**Proposed Subdivision**

**Butson property, Wanaka- Luggate Highway**

**Landscape Assessment Report  
Anne Steven Landscape Architect**

**From:** Dan Curley  
**Sent:** Wed, 16 Dec 2020 11:41:24 +1300  
**To:** Sarah Gathercole  
**Cc:** Kerry Butson  
**Subject:** RM200946 - K & J Butson - s.92 request for further information  
**Attachments:** 5098.2R.1E - Proposed Subdivision.pdf, Butson AEE (151220).pdf, Fig 3 Landscape Scheme Plan Dec 2020[1].pdf

Scale 1:1000 @ A1  
1:2000 @ A3  
DRAWING & ISSUE No.  
5098.2R.1E

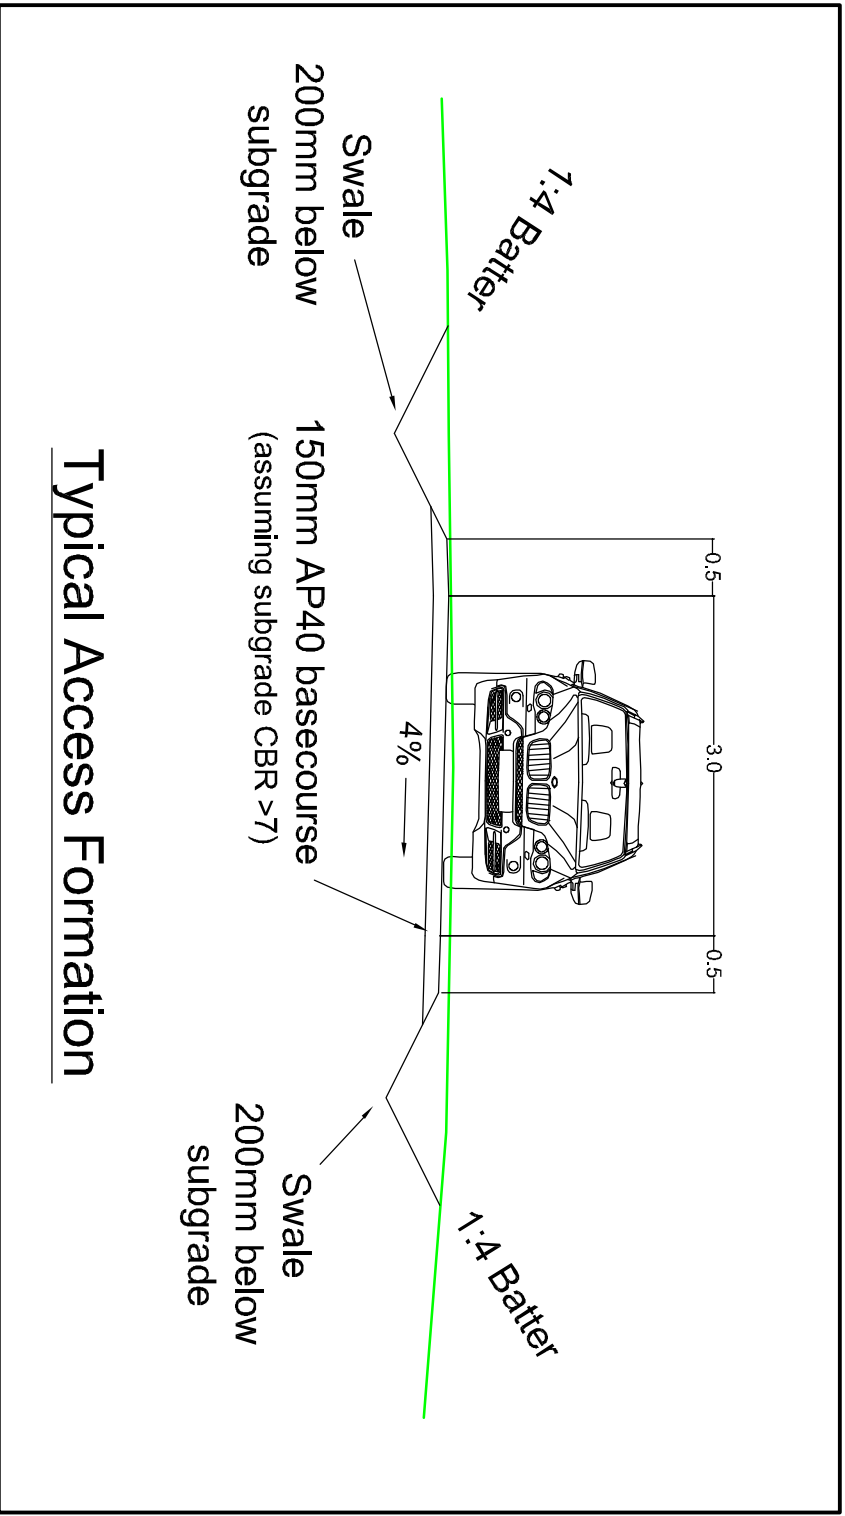
5. *Please identify what the blue dotted line on the Scheme Plan relates to?*

7. *Please provide two survey ties to each building platform on the scheme plan. Please advise why the ties are not on the edge of the proposed building platform on proposed Lot 5.*

8. *Please provide the rights of way with unique identifiers on the scheme plan to confirm whether Lot 4 will have access off the proposed right of way or directly from the highway and identify the proposed access for Lots 3 and 5.*

9. *The AEE and the scheme plan don't appear to match in relation to proposed Lot 5, with the AEE stating that the building platform will be 900m<sup>2</sup> and the Scheme Plan showing 1000m<sup>2</sup>. Please confirm.*

11. *Please provide details of the earthworks required for the construction of the rights of way, including a cross section of the rights of way formation. (Please note that the rights of way will need to be formed in general accordance with figure E2 of the QLDC Land Development and Subdivision code of practice. Formed width will need to be 3.5m to ensure fire applicants can access safely in an emergency).*

**The blue dotted line is existing in ground water reticulation alignments.**

**This detail is currently being reviewed by Bruce of Aurum Surveyors. It appears that the line work is not visible on the pdf. version submitted to Council. This will be corrected, however is a technical consideration and so should not contribute to any scope issues.**

**There will only be two crossings/access points to the subdivision. The lower terrace containing proposed Lots 2 & 5 will be serviced from one access point only, while Lots 1,3 & 4 (upper terrace) will be accessed via the other existing crossing as indicated. There will be no ability for any lot to access the highway independently from the ROWs.**

**1,000m<sup>2</sup> is correct. Please note the error is within the AEE. New version attached with correct.**

**Approximate earthworks volumes are now included on the attached scheme, as well as a typical cross section.**
